## PRODUCT SUPPORT BULLETIN BULLETIN NO. 312

MACHINE: **Anchor Applicator Model E**

SUBJECT: **Lifting Bail Cable Kit – p/n 98680016**

**Lifting Cable Installation**

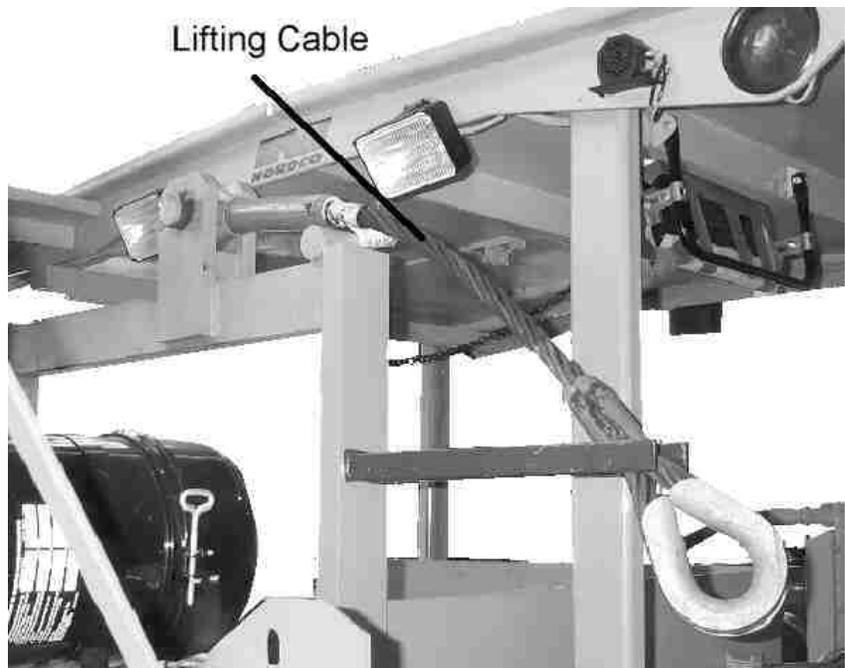
This Lifting Bail Kit, p/n 98680016, has been designed to allow easy, safe hooking to a crane when lifting of the Anchor Applicator Model E.

The kit consists of a Lifting Cable, a clevis, and several other small parts that are welded to the original lifting bail. NORDCO recommends that you have a certified welder do the welding. Installation should take about 2 hours.

With the cable installed, the machine may be hooked easily from the ground without climbing up on the machine itself. The cable remains permanently attached to the lifting bail and is readily available for use.

Machine with serial numbers 680232 and above have the Lifting Cable installed as standard equipment.
